# APPROVED MINUTES

## March 20, 2014 Standards Committee Meeting

RE: Minutes from the March 20, 2014 Standards Committee Meeting

REVISION TO STANDARD SPECIFICATIONS, SPECIAL PROVISIONS AND DRAWINGS  
REVISION TO STANDARD DRAWINGS

802-SNDH-02 SIGN PLACEMENT DIVIDED HIGHWAY INTERSECTION MEDIAN WIDTH  
 > 30 FT (DRAFT)

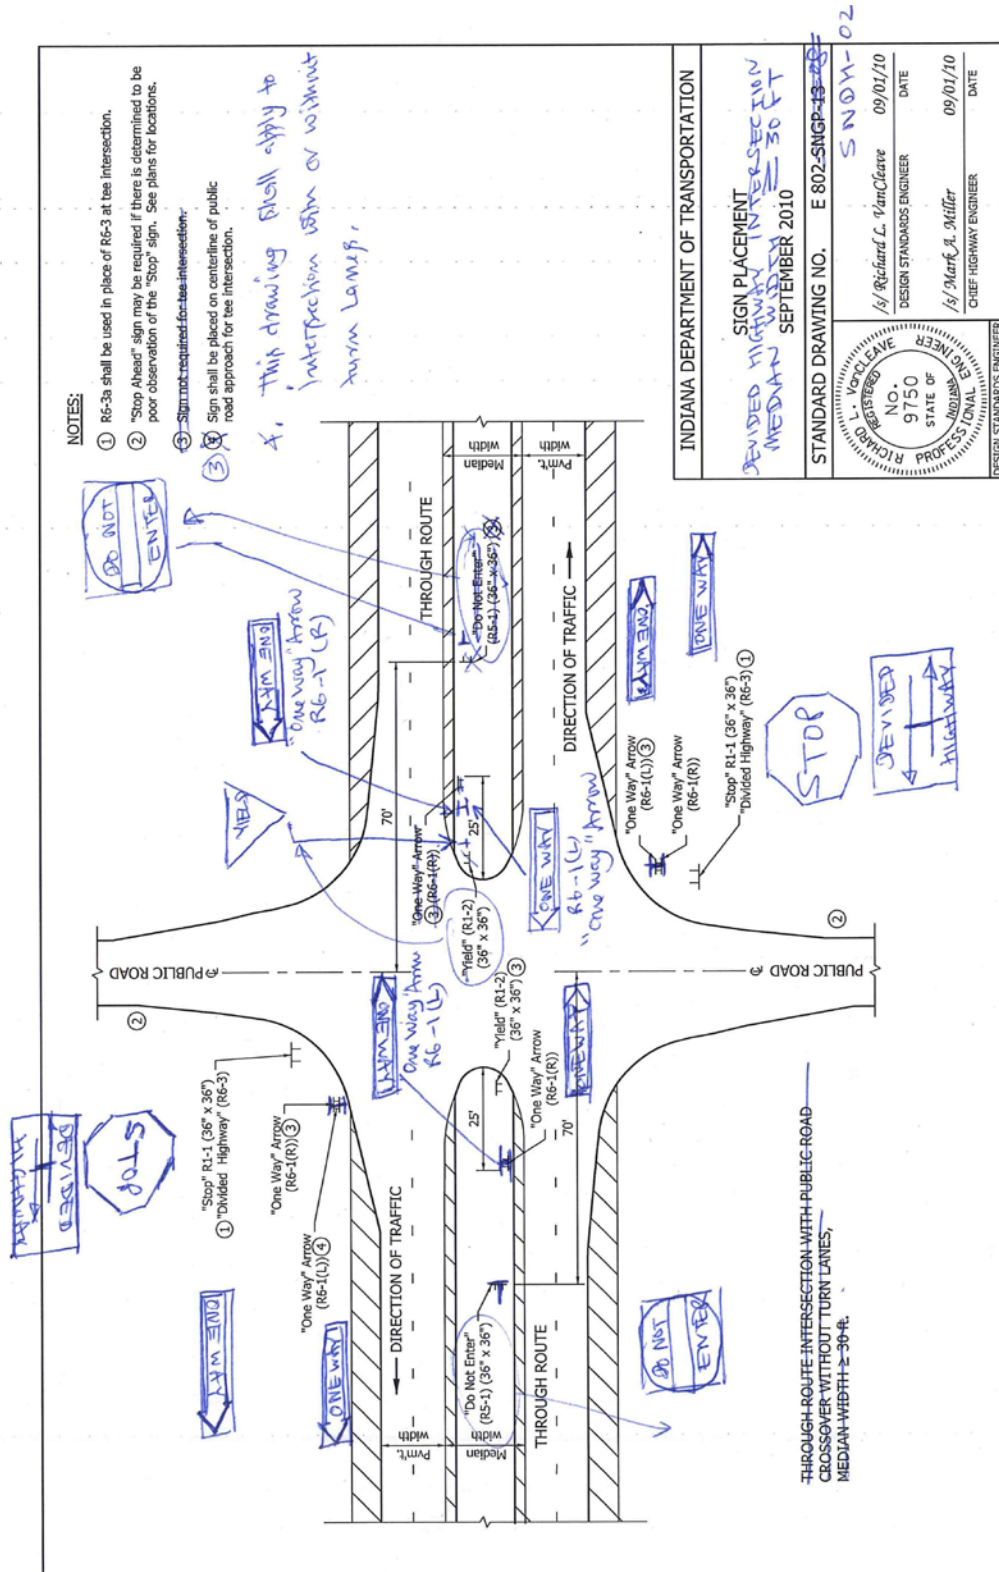
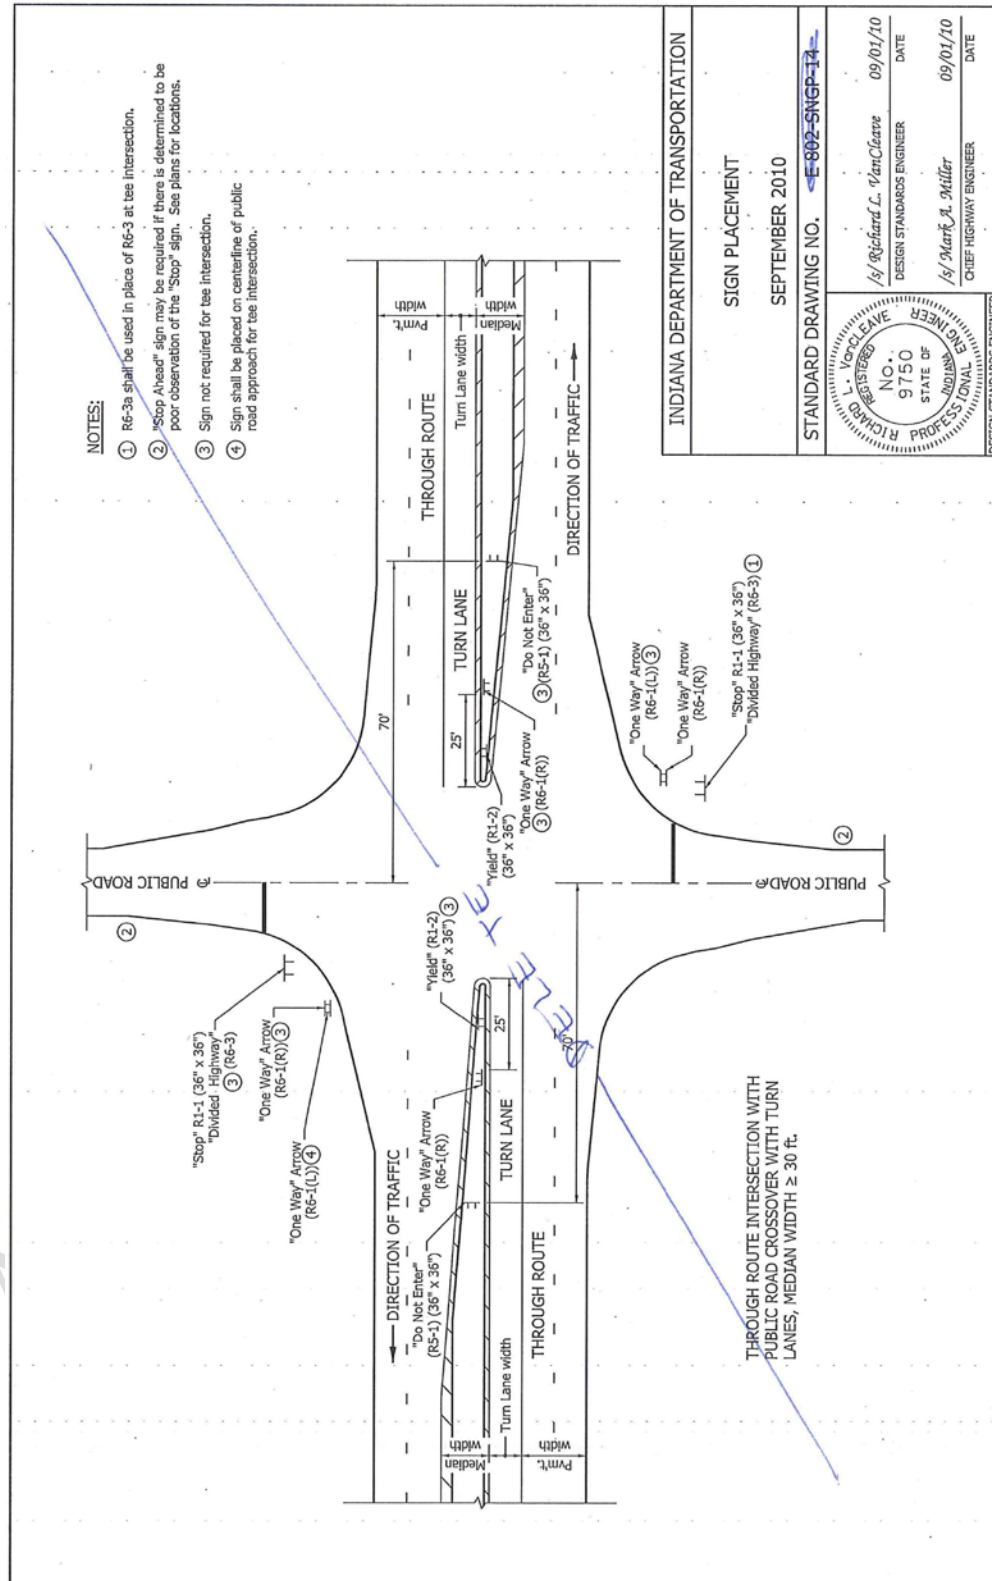
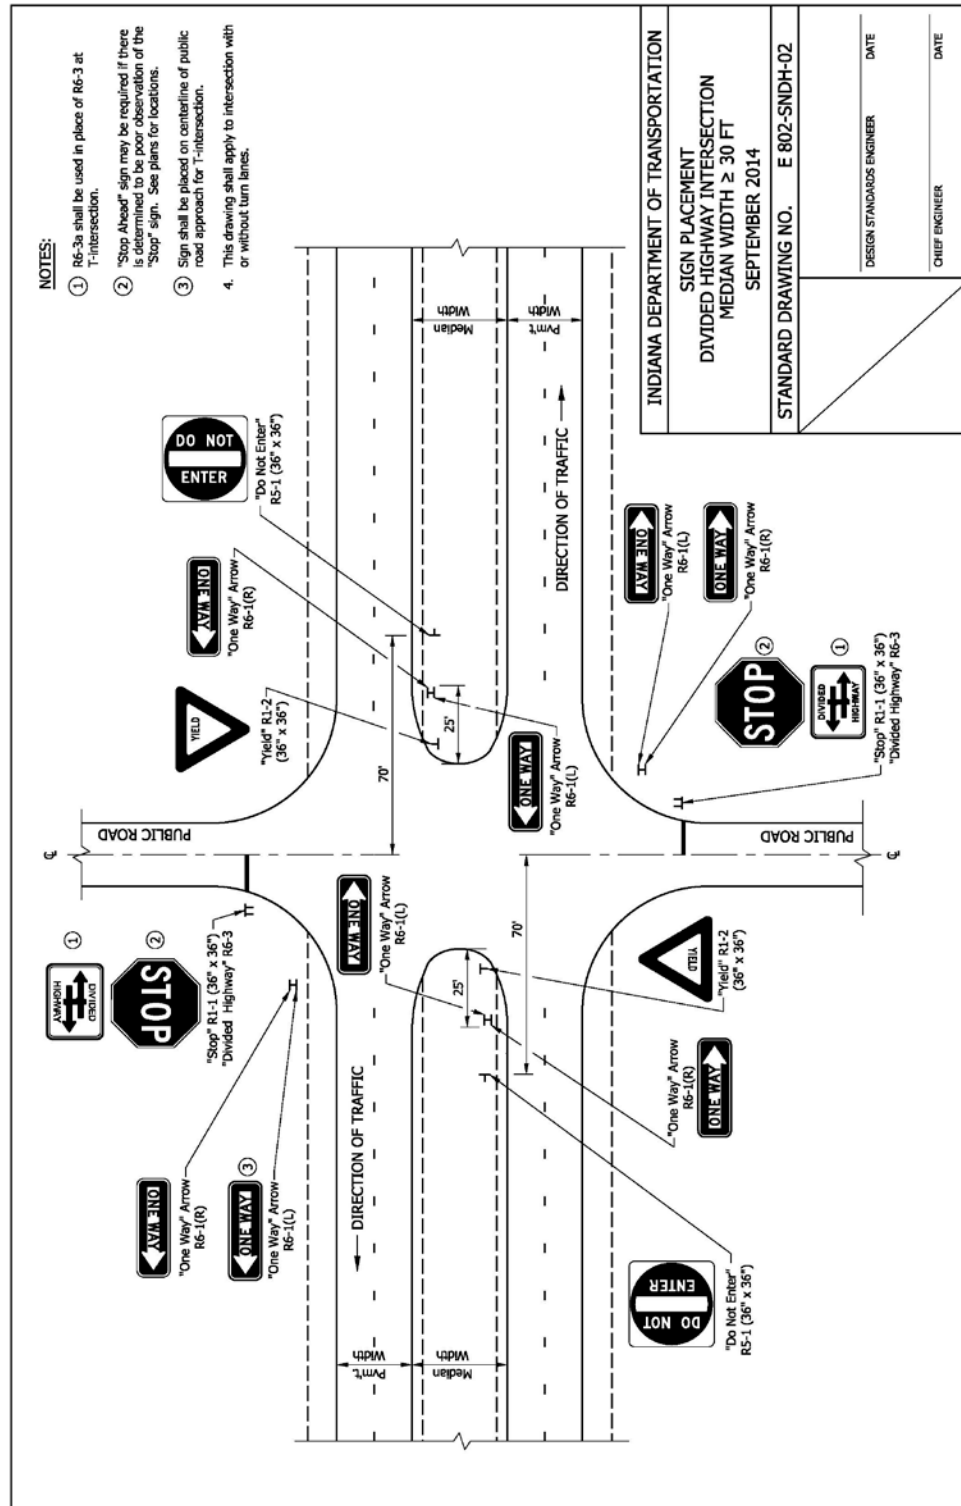
PROBLEM(S) ENCOUNTERED: Standard Drawings 802-SNGP-13 and 802-SNGP-14 showing Sign Placement for divided highway intersections with medians 30 ft or wider do not include the ONE WAY signs in the median that are required by the 2011 IMUTCD.

1. 802-SNGP-11 and 802-SNGP-12 show identical signing
2. 802-SNGP-13 and 802-SNGP-14 also show identical signing
3. 802-SNGP-05, 802-SNGP-06, 802-SNGP-07 which show sign post and foundation data can be condensed.

PROPOSED SOLUTION: Revise Standard Drawing 802-SNGP-13 and place in a new series, 802-SNDH. Also move 802-SNGP-11 into the new series and eliminate 802-SNGP-12 and 802-SNGP-14.
